ALTERNATE 1:

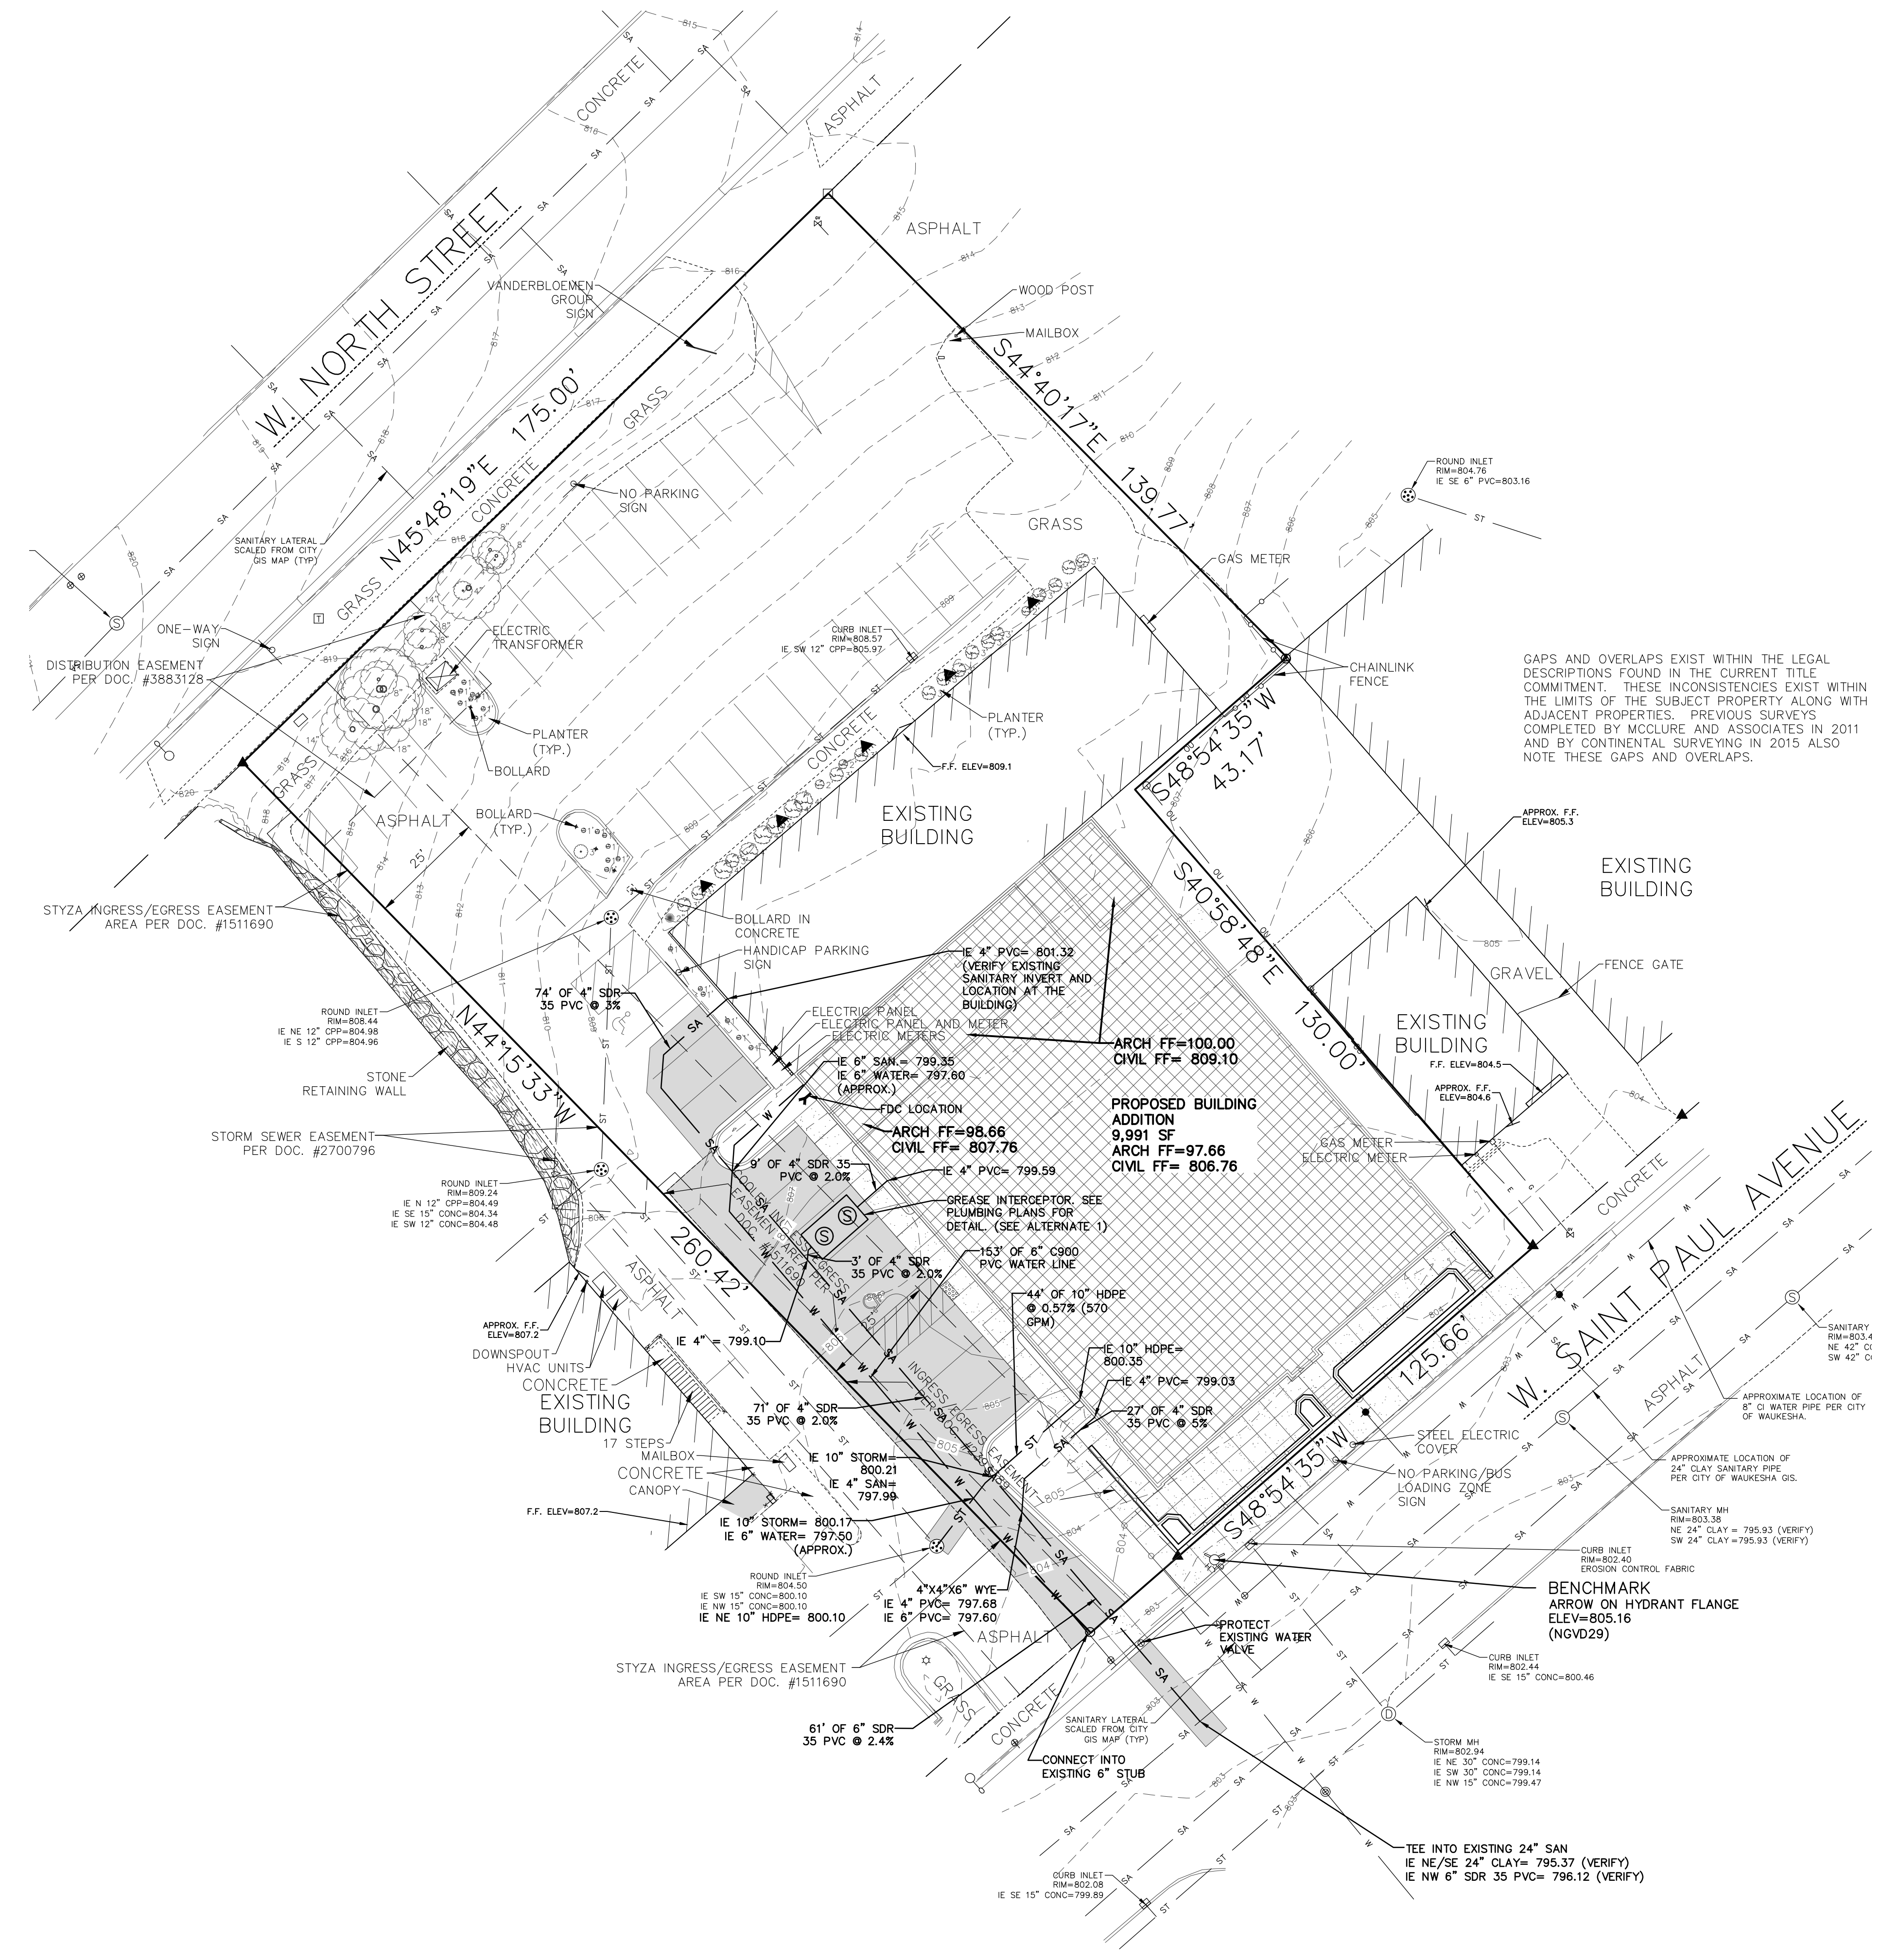
– ELIMINATE THE GREASE INTERCEPTOR
SOUTHWEST OF THE BUILDING. RUN 96'
OF 4" SDR 35 PVC AT 2.7% FROM THE
BUILDING TO THE 4"x4"x6" WYE IN THE
SAME ALIGNMENT. PROVIDE CLEANOUTS
PER STATE CODE.
